SUBJECT: COMANCHE PEAK STEAM ELECTRIC STATION
CONTROL OF HEAVY LOADS: NUREG-0612

COMANCHE PEAK STEAM ELECTRIC STATION
CONTROL OF HEAVY LOADS: NUREG-0612

RESPONSE TO ENCLOSURE 3 of
NRC LETTER DATED DECEMBER 22, 1980

FIGURE 1

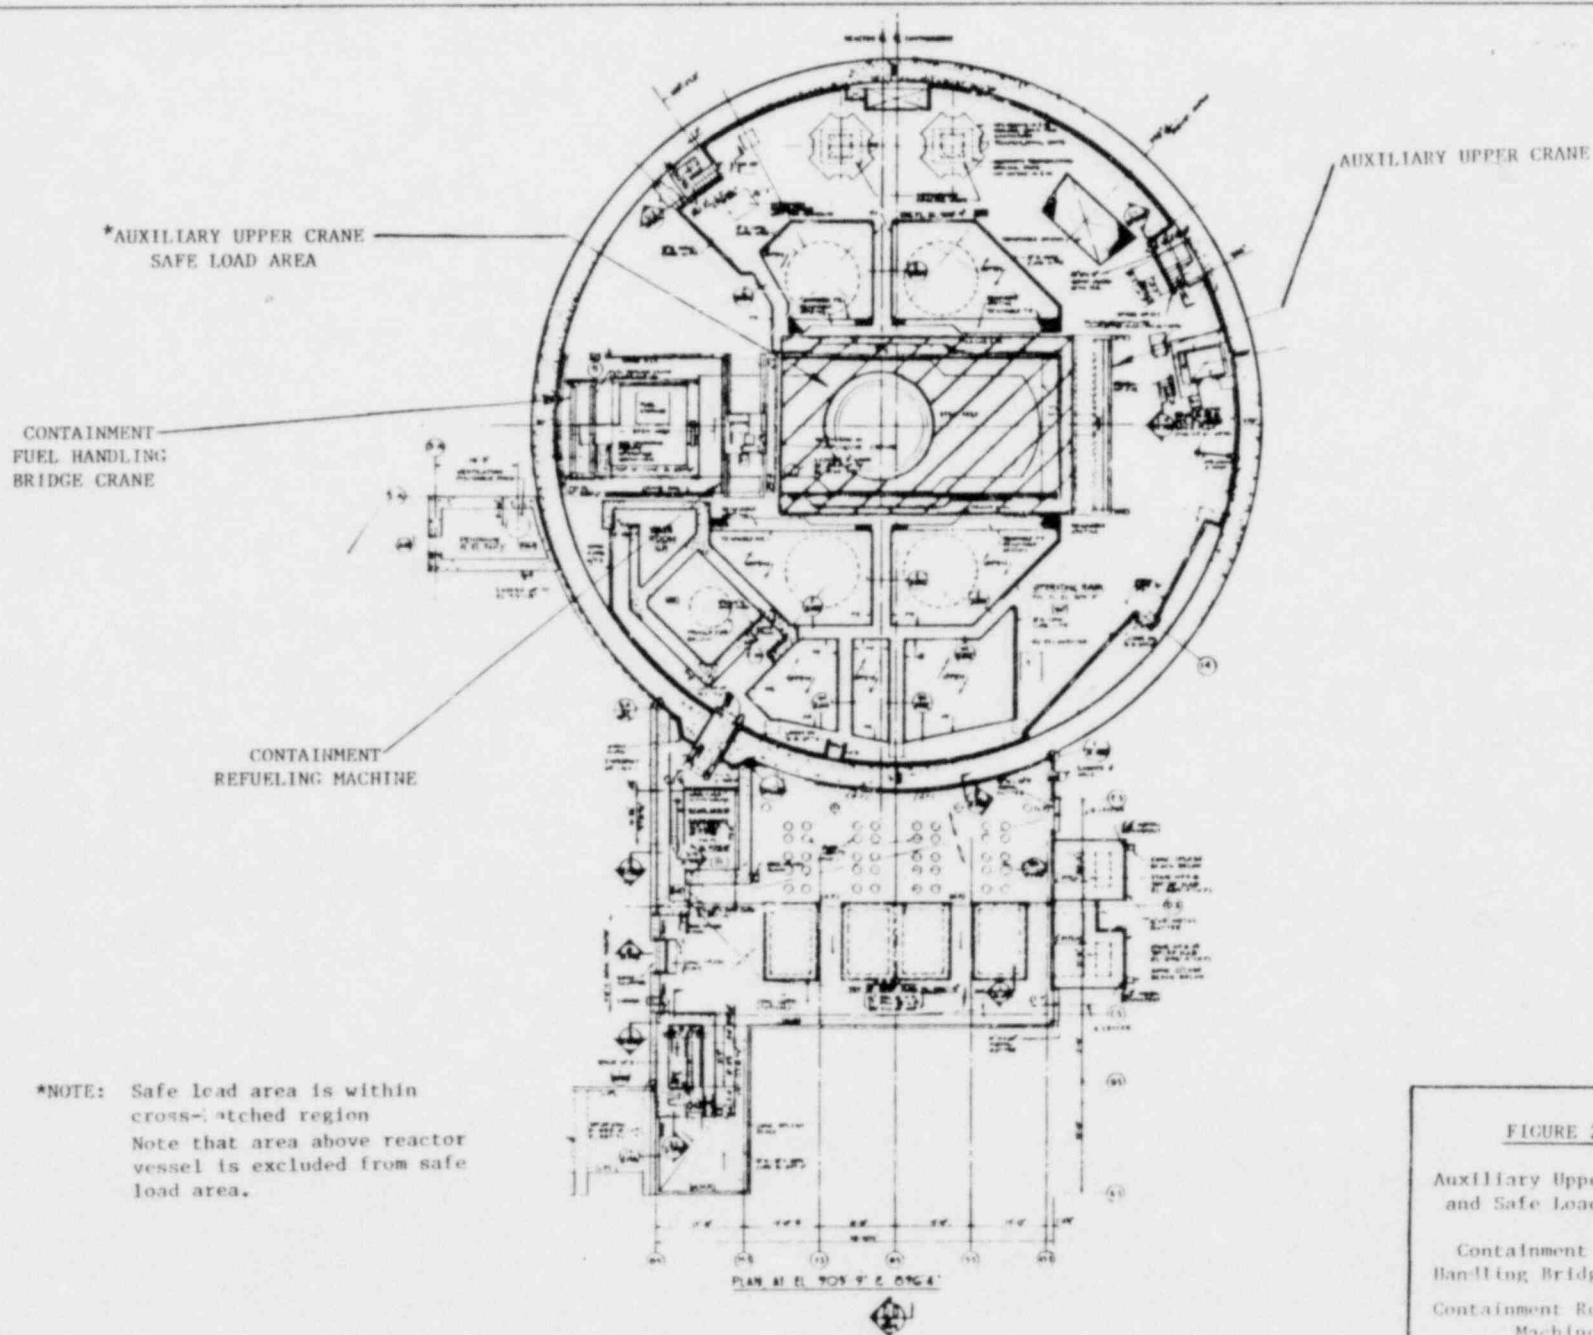
A. Fuel Building Overhead Crane -
(CPX-MESCFC-01)

This crane is shown in Figure 1 along with the safe load area illustrated by the cross-hatched region. Although this crane does not travel directly over the spent fuel pools, a safe load area has been defined outside the spent fuel pool areas. The safe load area includes the fuel receipt and inspection areas and the shipping cask receipt and decontamination area.

H. Fuel Building Fuel Handling Bridge Crane -
(TBX-FHSCFB-01)

This crane is shown on Figure 1. The crane is designed to handle a fuel assembly and components with its associated handling tool and therefore does not carry "heavy loads" as defined in NUREG 0612. No safe load areas are therefore required.

FIGURE 2

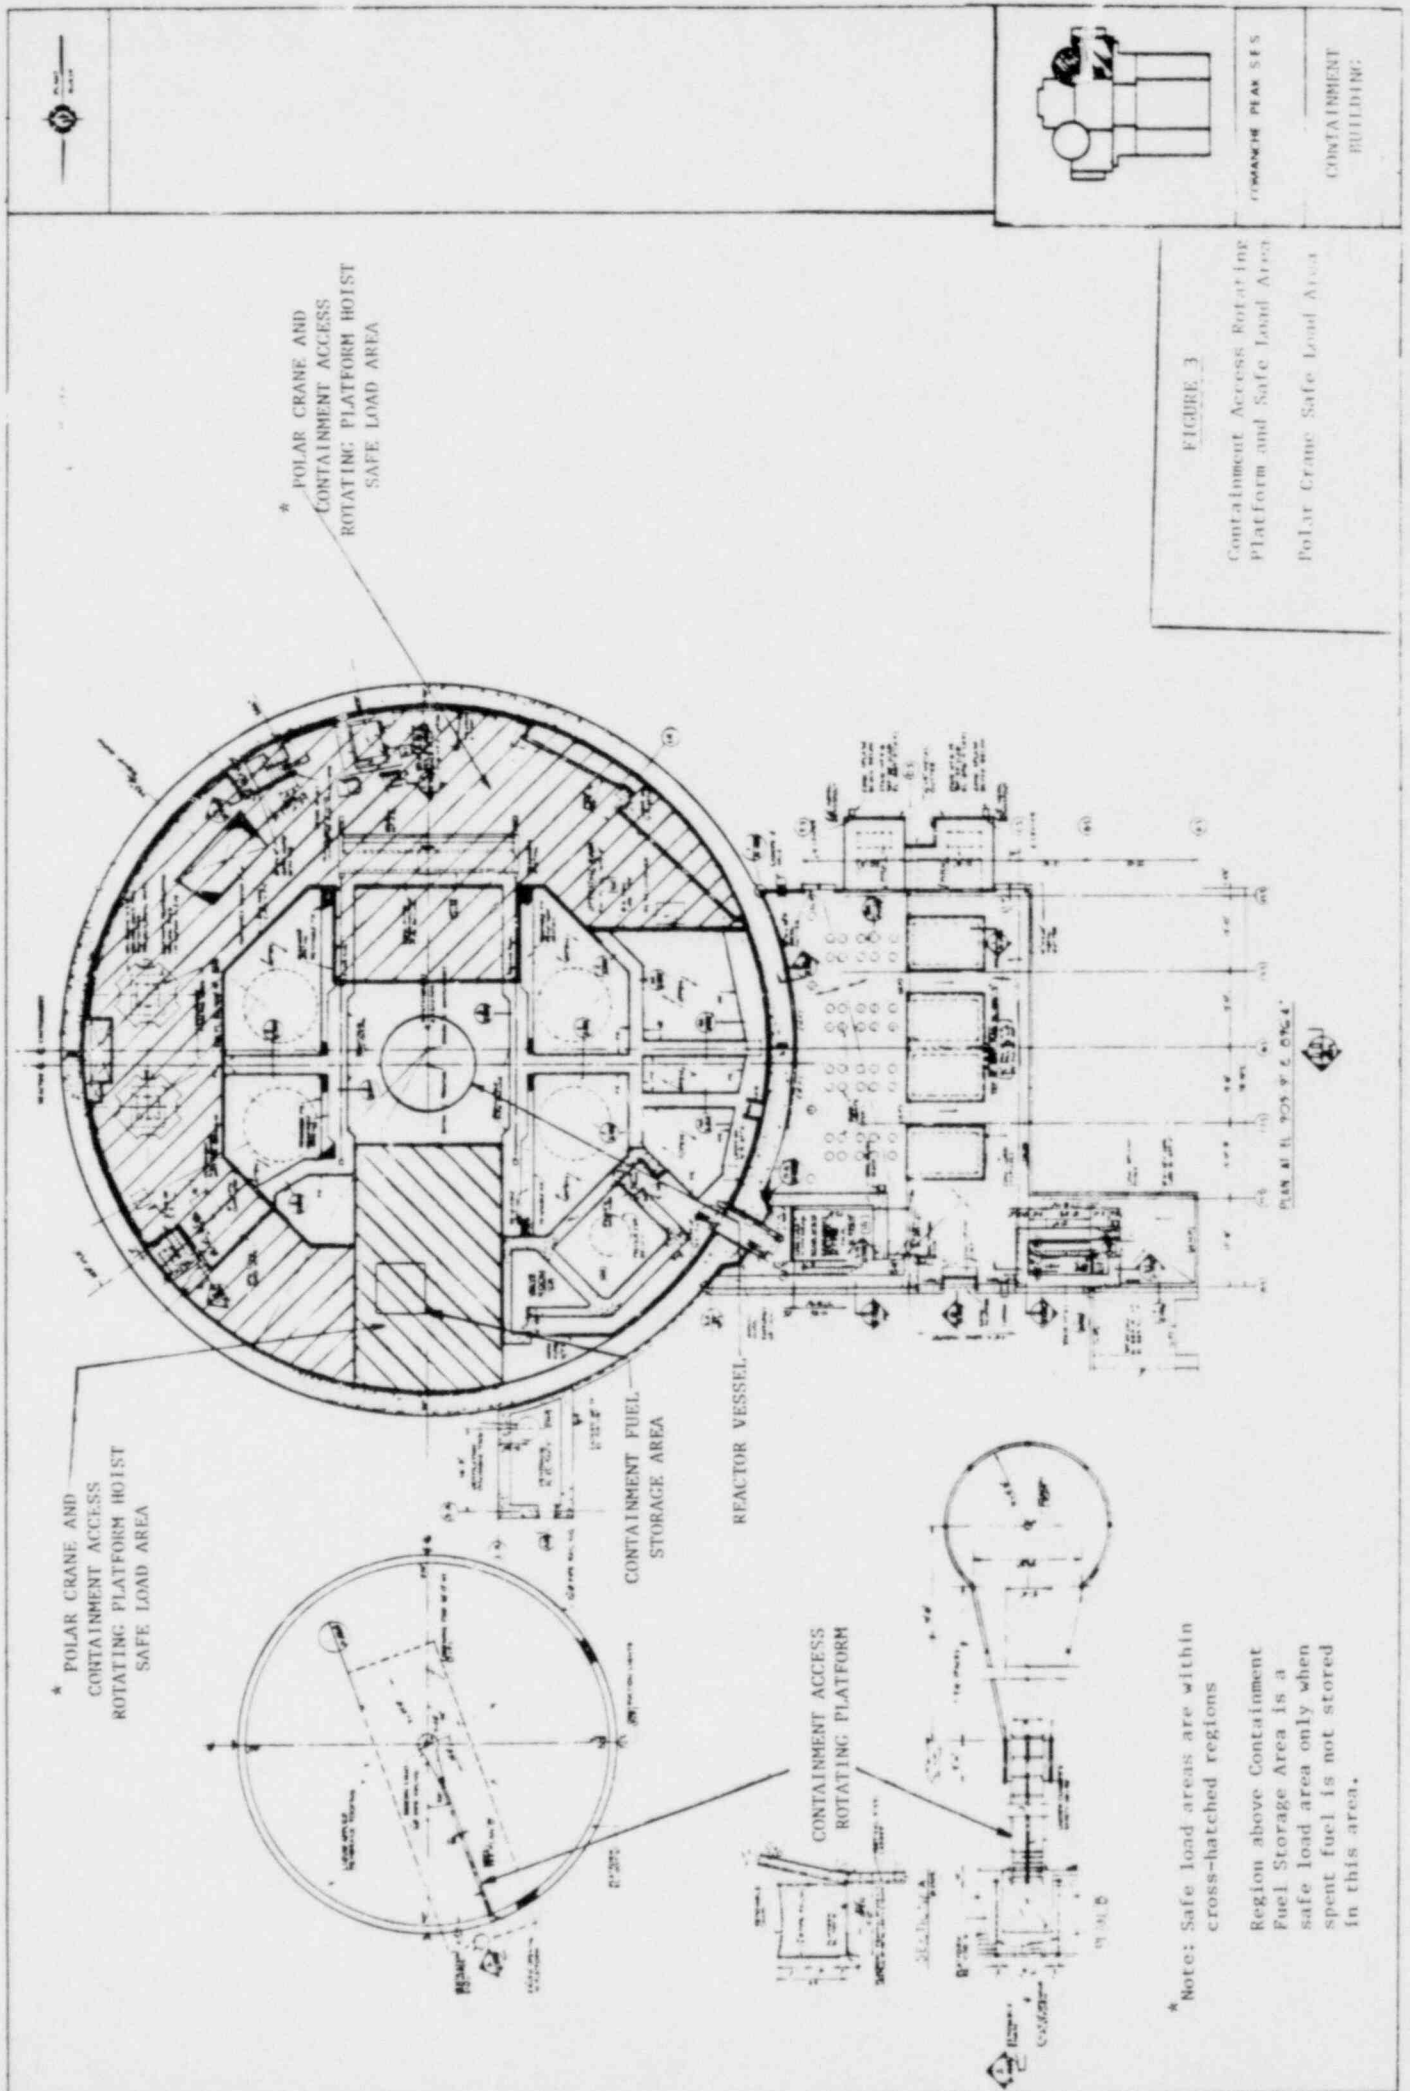
B. Containment Auxiliary Upper Crane -
(CP1&2-MESCCA-01)

This crane and its associated safe load areas are shown in Figure 2. The area serviced by this crane includes the reactor vessel and therefore the potential exists for a heavy load drop into the vessel. As a result, the safe load area is defined outside of the reactor vessel area as indicated by the cross-hatched area in Figure 2.

E. Containment Building Refueling Machine -
(TBX-FHSCMC-01)

This crane is shown on Figure 2. This crane is specifically designed to handle fuel assemblies and therefore does not handle "heavy loads" as defined in NUREG 0612.

FIGURE 11

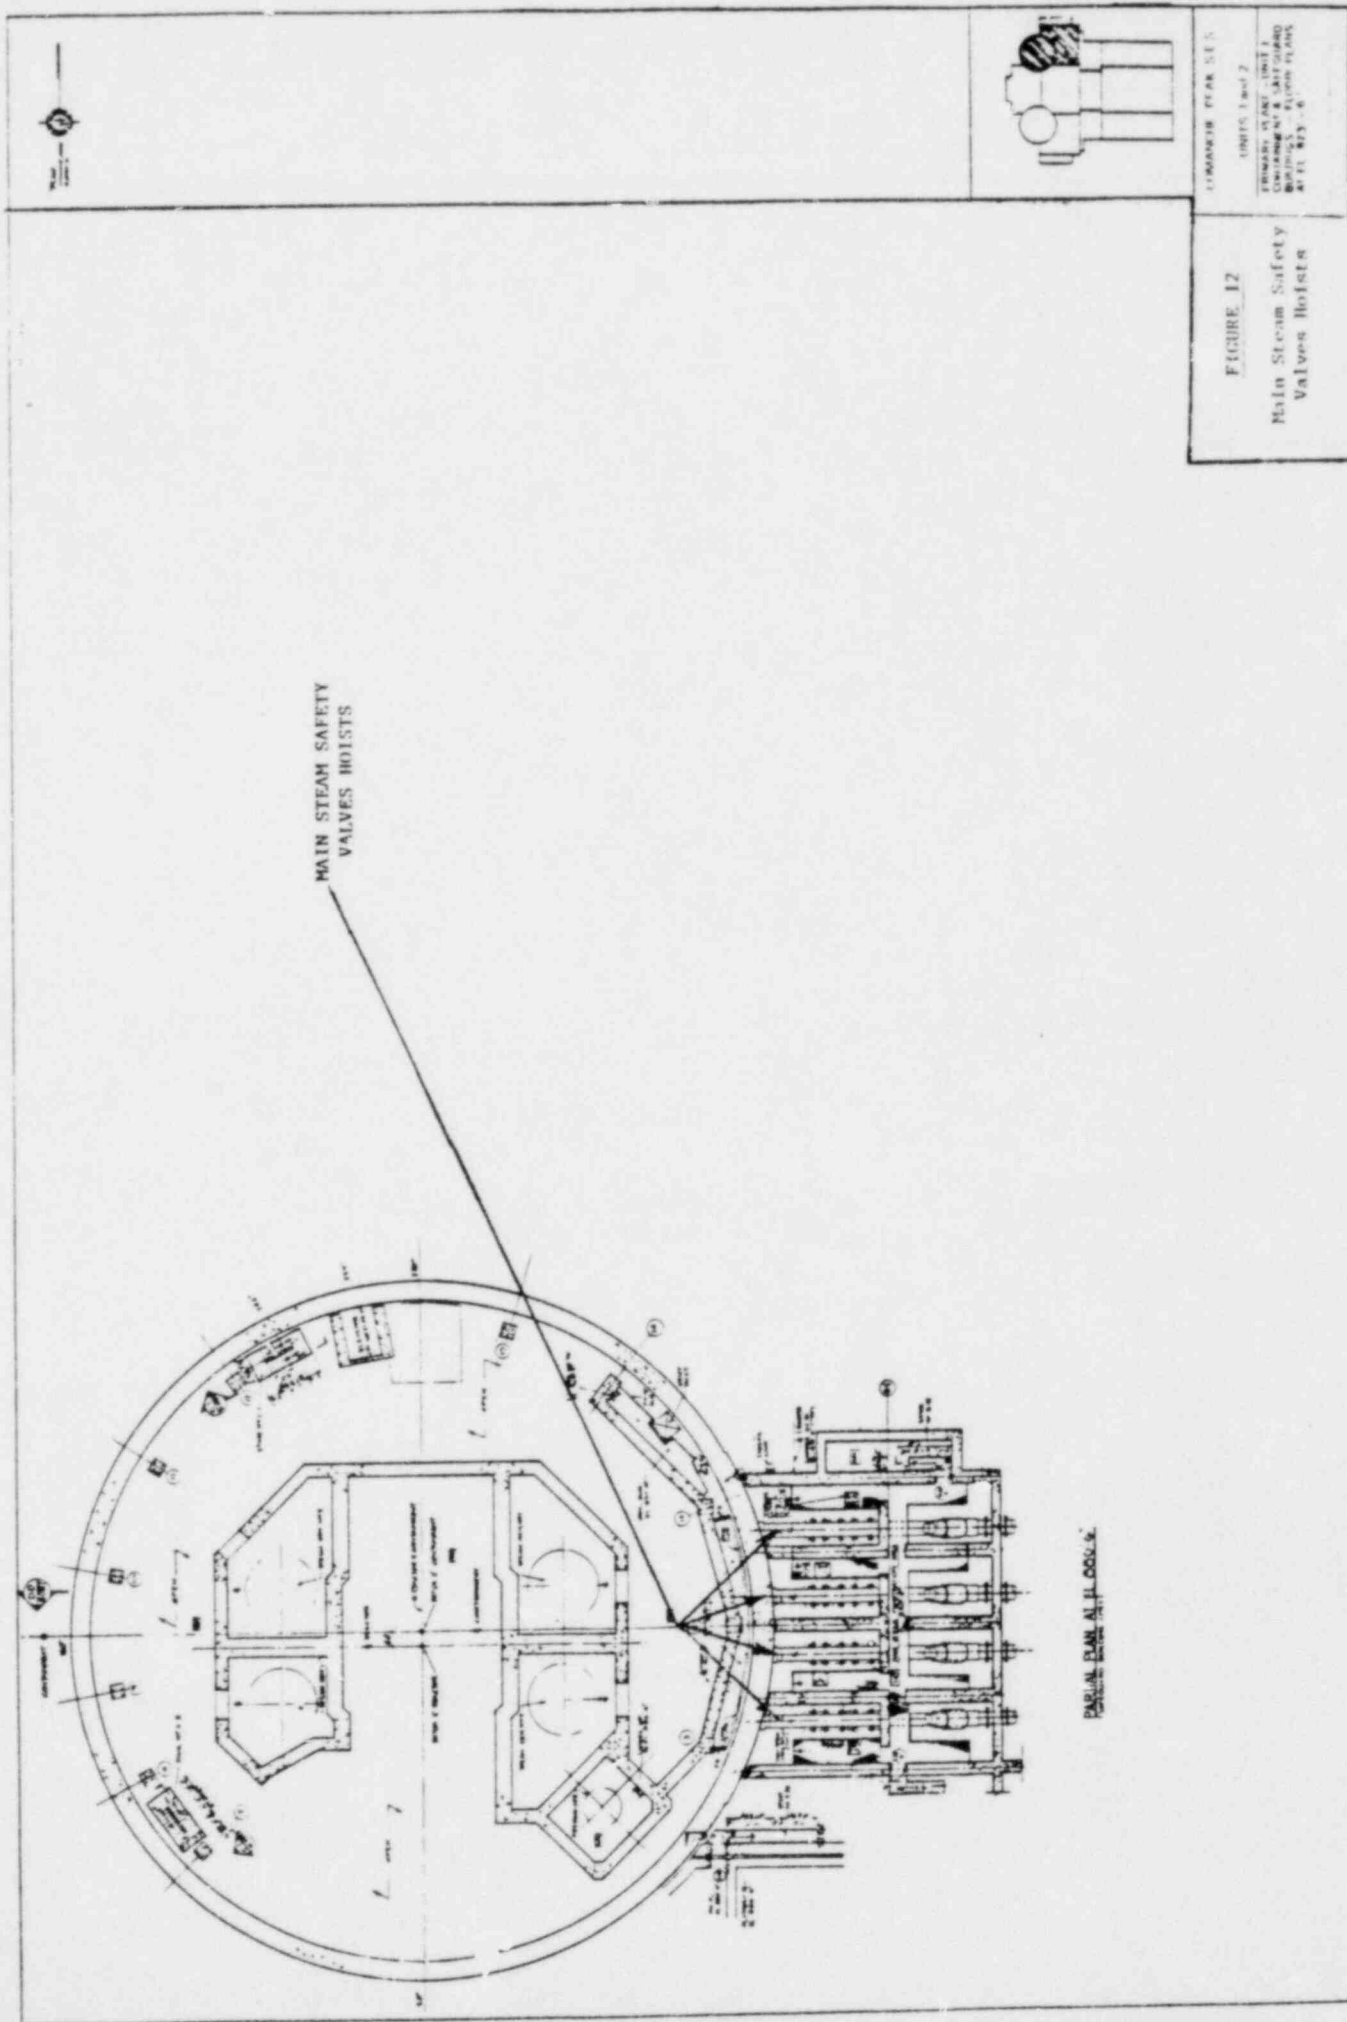
| K. Spent Fuel Pool HX Hoist

(CPX-MEMHCH-43,44) | Figure 11 |
